AGENDA
MEETING OF THE
HIGHWOOD PLANNING AND ZONING COMMISSION

4.1 Petition for a Planned Unit Development from Allan Dennis, of Midwest Young Artists (MYA). The petitioner has applied to permit the use of vacant land, parcel #16-10-401-014 in Highwood IL, 60040 to be used as a concert hall and musical campus.

Subject: Resubmittal of Request for Zoning Change

Subject: MYA Campus Expansion
Conceptual Plan #2
(CBBEL Project No. 170196.R2301)

CONCEPTUAL PLAN #2

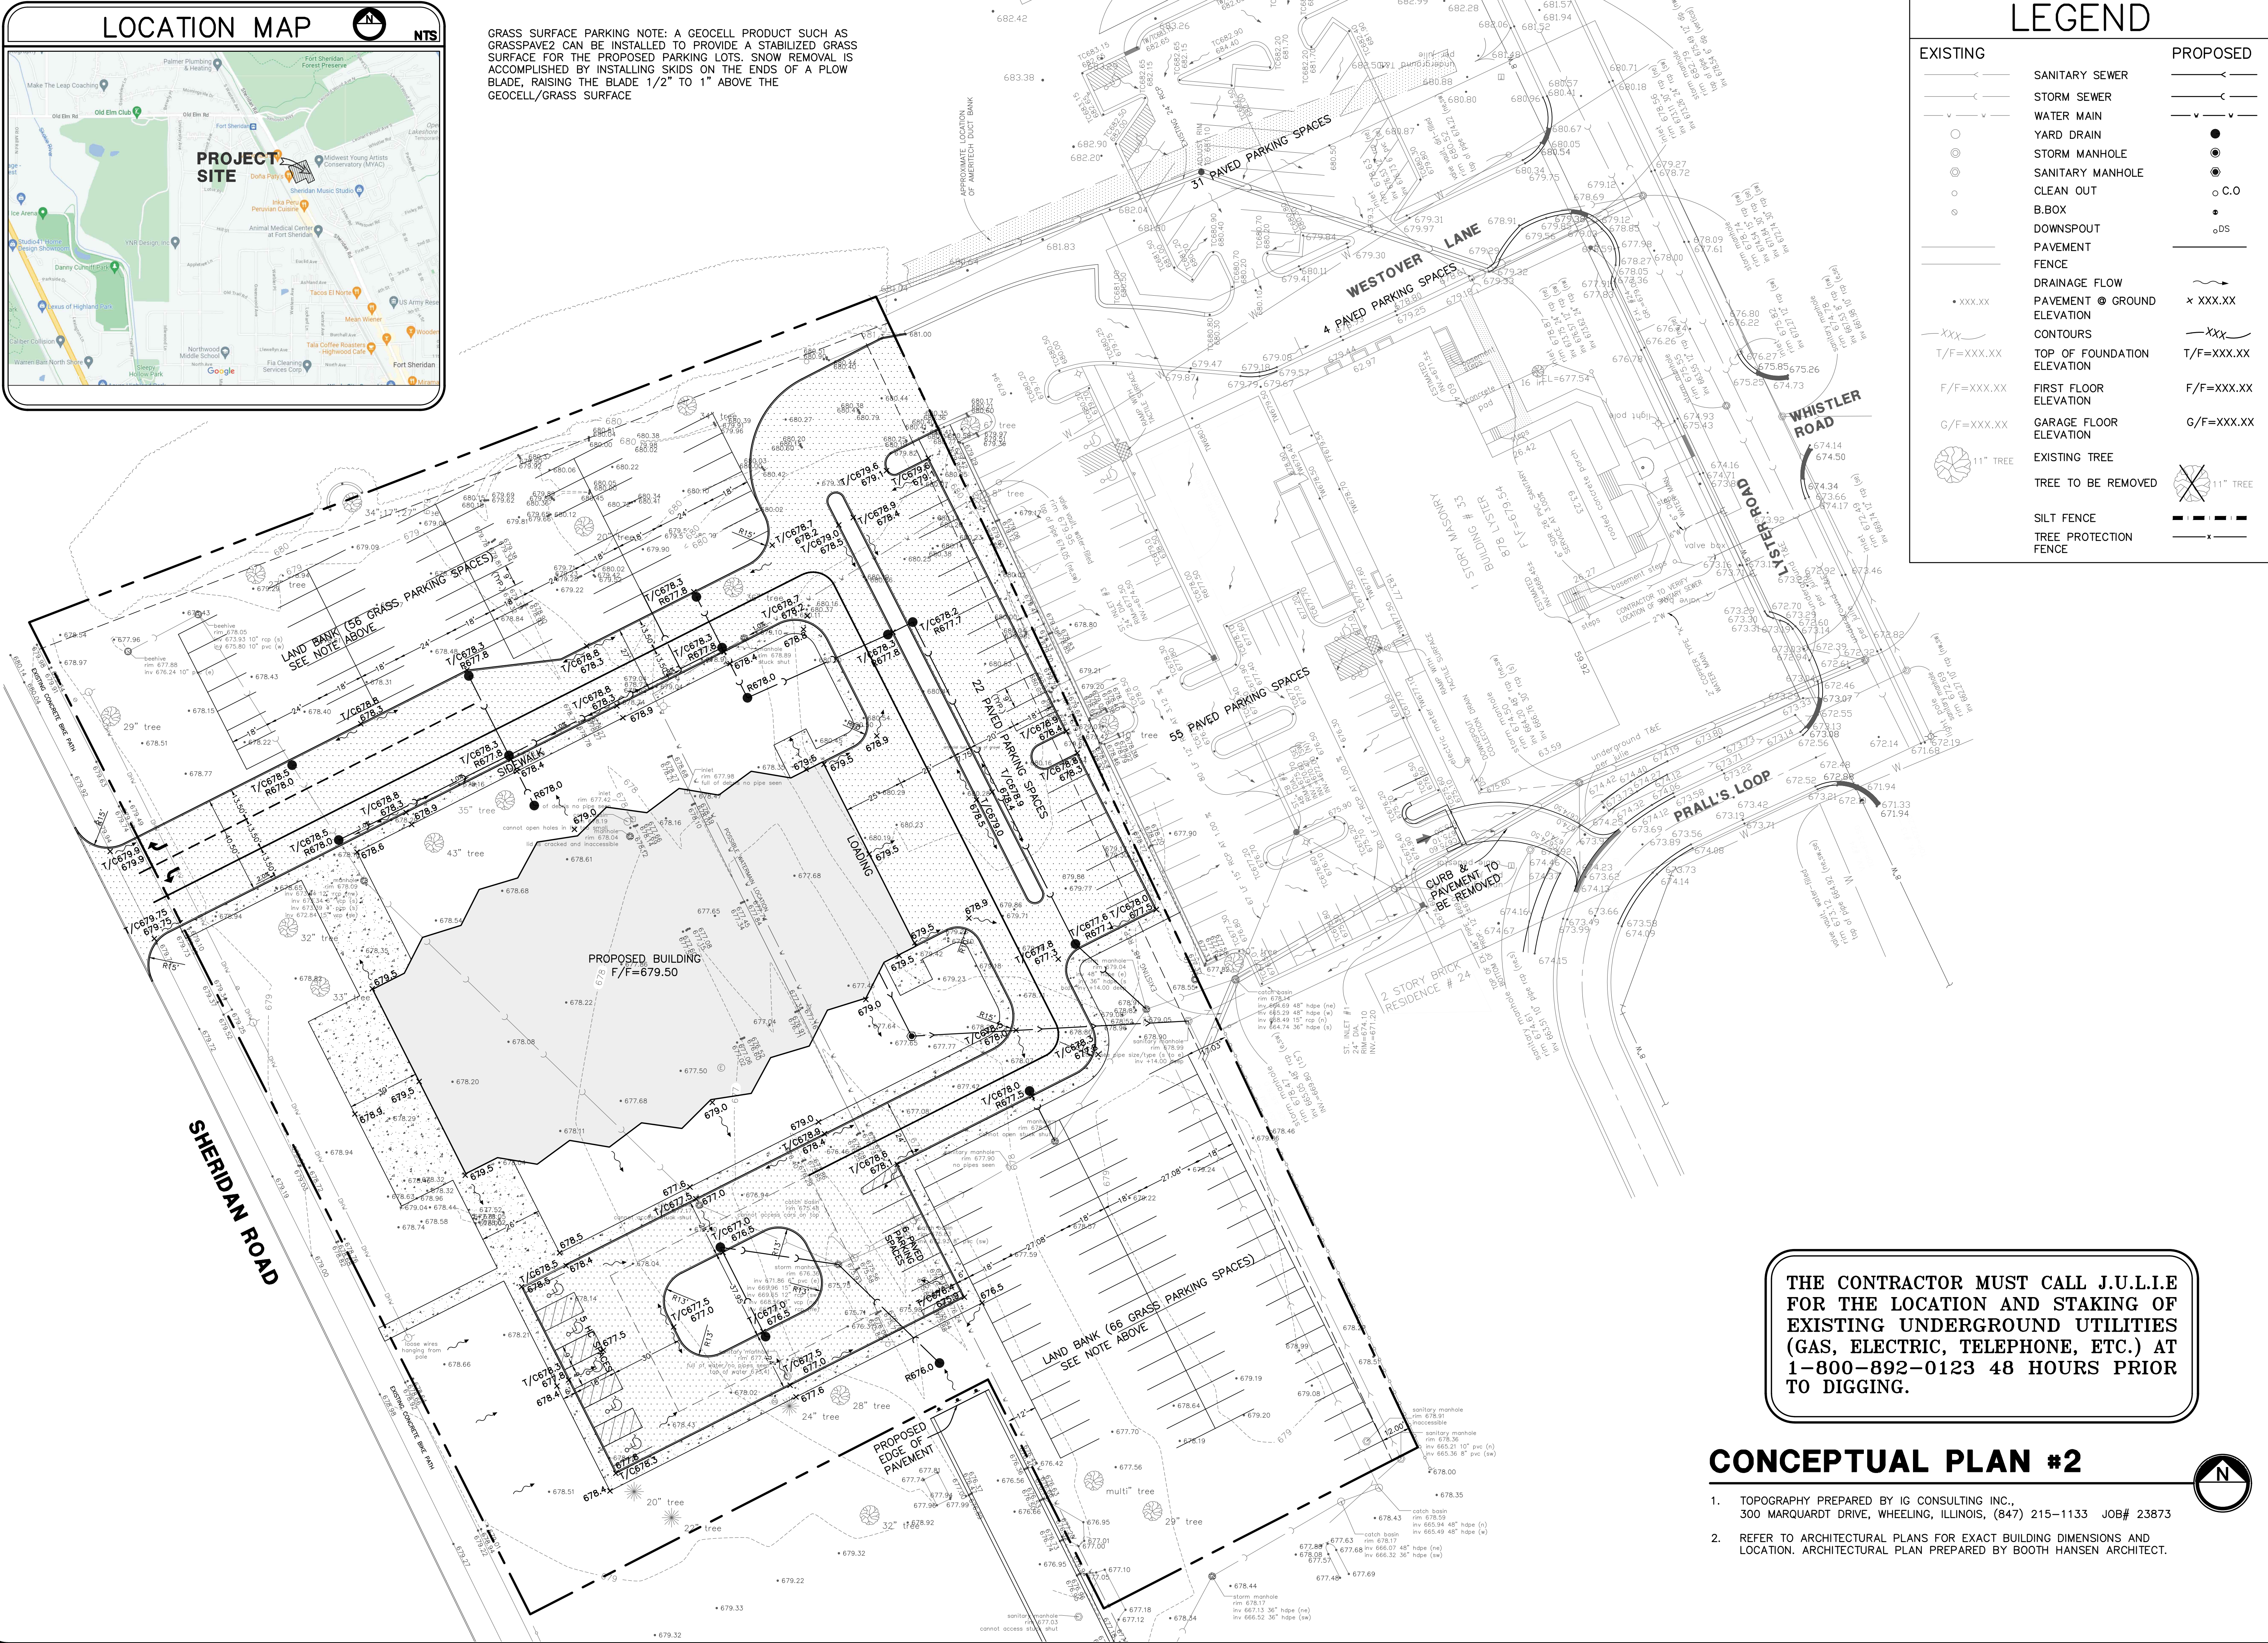
We have reviewed the Traffic and Parking Management Plan for Large Events, and Conceptual Plan #2. Our Traffic Operations staff has reviewed the Traffic and Parking Management Plan for Large Events. Our Municipal staff has reviewed the Conceptual Plan #2 as well. Based on our teleconference of April 23, 2025 and follow-up correspondence from Kevin Lewis of IG Consulting, we offer the following:

Conceptual Plan #2:

1. The traffic impact study (TIS) and large event parking plan are acceptable.
2. We find the Concept Level Engineering Plans to be generally complete and acceptable for concept level plans.

3. A Watershed Development Permit is required if more than 3 acres of land is hydraulically disturbed. Please refer to Article 3.300.06 of the Lake County Watershed Development Ordinance. This shall be submitted with final engineering plans. Based on our discussions and supplemental information provided, there is an agreement that the final design will be in full compliance with City and Lake County codes and stormwater detention will be provided on site. Several alternatives are being considered for stormwater detention storage, including but not limited to, an underground stormwater vault or chambers, and the release of stormwater will be restricted as required.. We understand that the City will not issue development permits until final engineering plans and reports provide documentation that the proposal is in compliance with City and County codes. The proposal will not include storage within the existing regional stormwater basin east of the site.

11/06/23
10:45:18

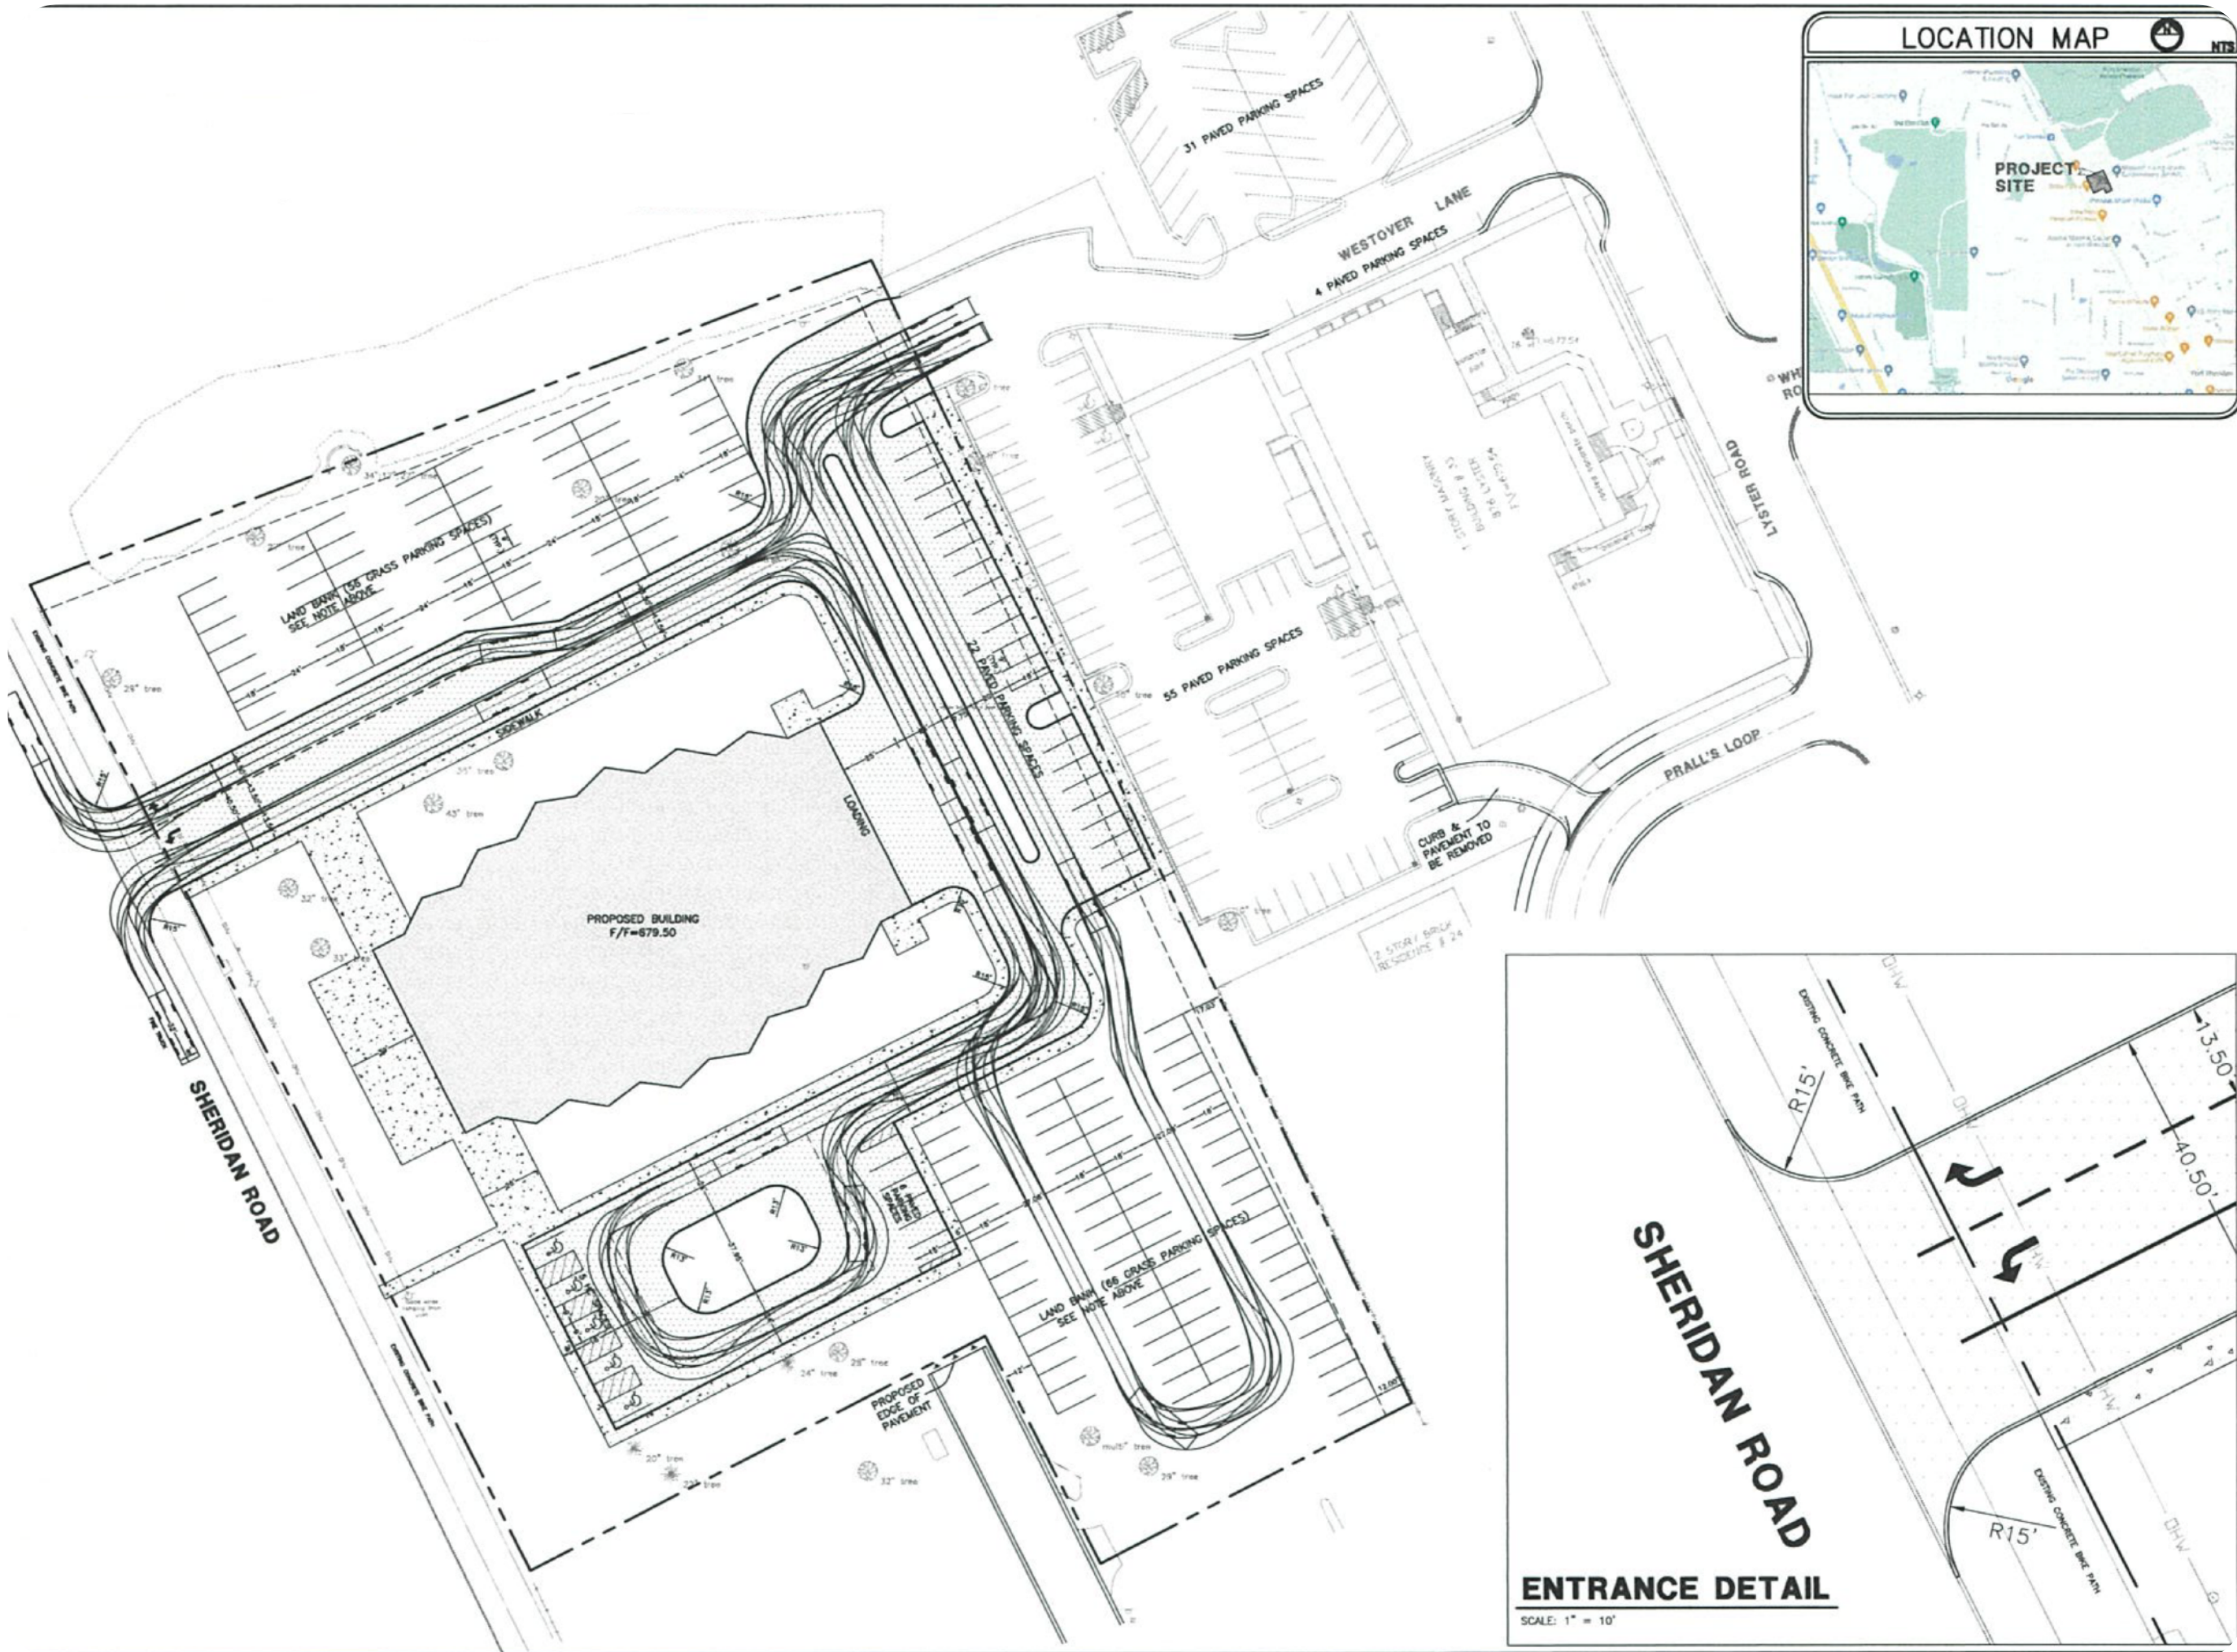
TEAPAC[Ver 9.50.02] - 15-Minute Counts: All Vehicles - Totals

TEAPAC[Ver 9.50.02] - 15-Minute Flow Rates: by Movement

Approach EB WB SB

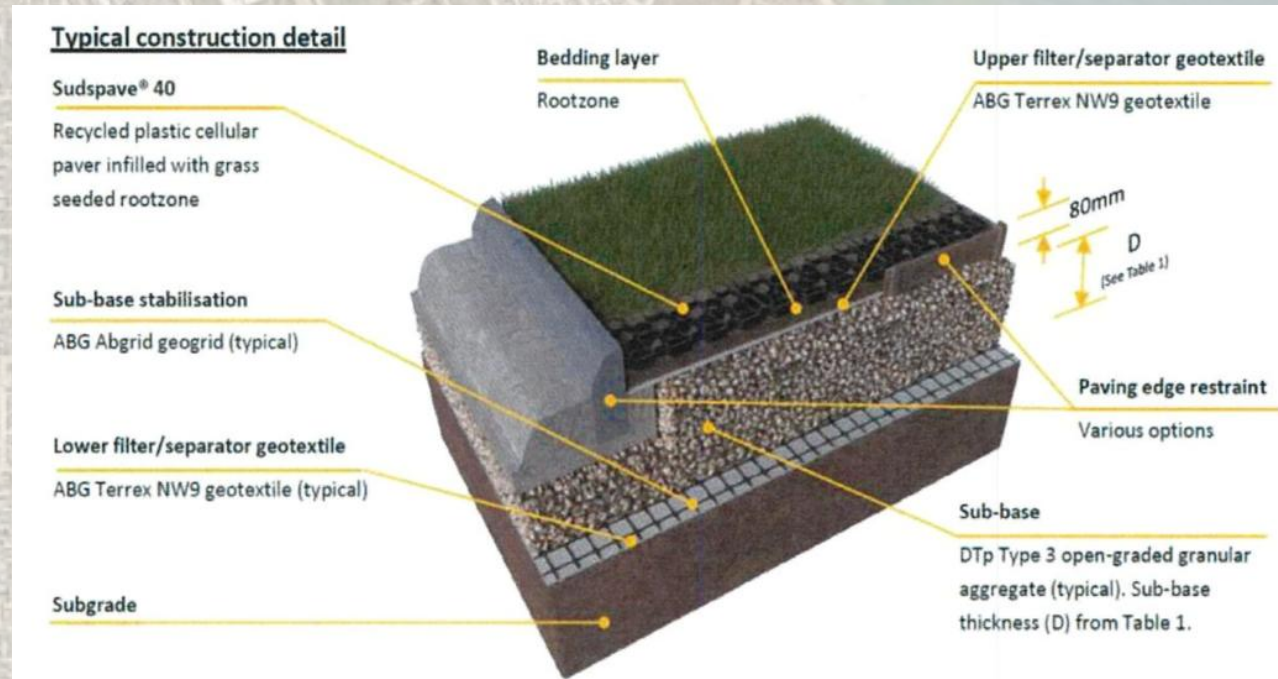
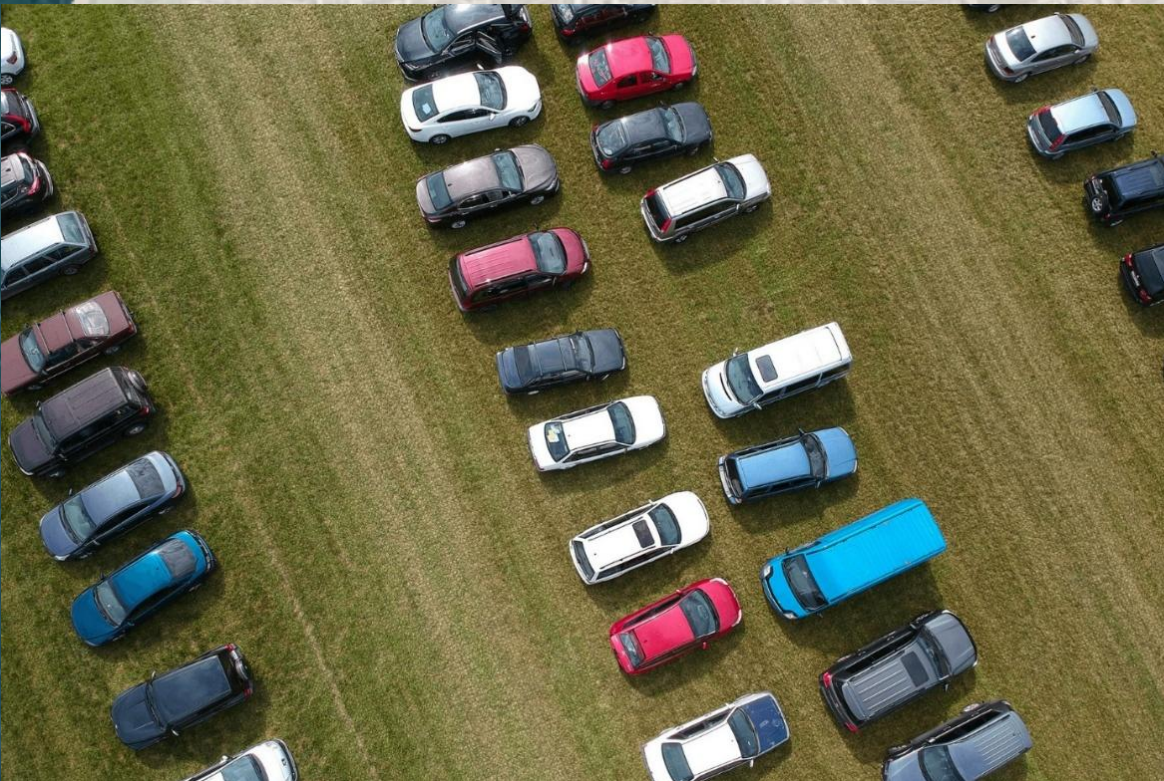
HCM LOS A

Capacity (veh/h) - - 982

HCM Control Delay (s) - - 8.7

7: West Lot Access Drive & Westover Road
